Recall Bulletin

PRODUCT EMISSION RECALL

SUBJECT: Oxygen Sensor Fracture

MODELS: 2011-2013 Chevrolet Express
2011-2013 GMC Savana
Cutaway Equipped with Gasoline or Liquefied Petroleum Gas (LPG) Fuel Engines

First and Second Design Sensors

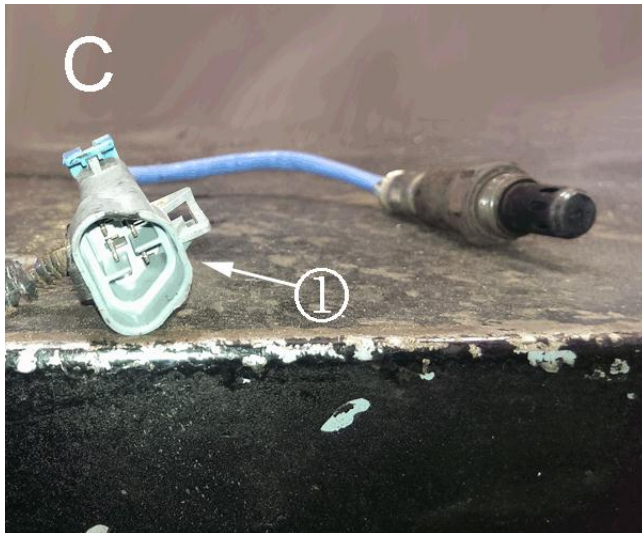
(A) 2011 through early 2013 OE production first design male connector. Replace the part with a second design part with a male connector, P/N 12637297. (B) 2011 through 2013 second design service part, P/N12637297. Do NOT replace this part unless the part has failed. If the part has failed, replace the part with the second design part with a male connector, P/N 12637297.

(C) This is the second design 2013 production sensor with the female plug (1). The sensor and plug change was made to indicate the new design. Do NOT replace this sensor, P/N12656071, unless the part has failed.

3. Determine if a first design (A) or second design (B) heated oxygen sensor is installed using a light and mirror.
 - If a second design (B), P/N 12637297, P/N 12656071 heated oxygen sensor is currently installed, no further action is required. Lower the vehicle. Refer to *Lifting and Jacking the Vehicle* in SI.
 - If a first design (A), P/N 12612571, heated oxygen sensor is in place, remove the sensor and replace it with a second design heated oxygen sensor. Refer to *Heated Oxygen Sensor Replacement –Bank 2 Sensor 2* in SI and *Heated Oxygen Sensor Replacement –Bank 1 Sensor 2* in SI.
4. After installing the new heated oxygen sensors, reprogram the ECM. Refer to *Engine Control Module Programming* in this bulletin.
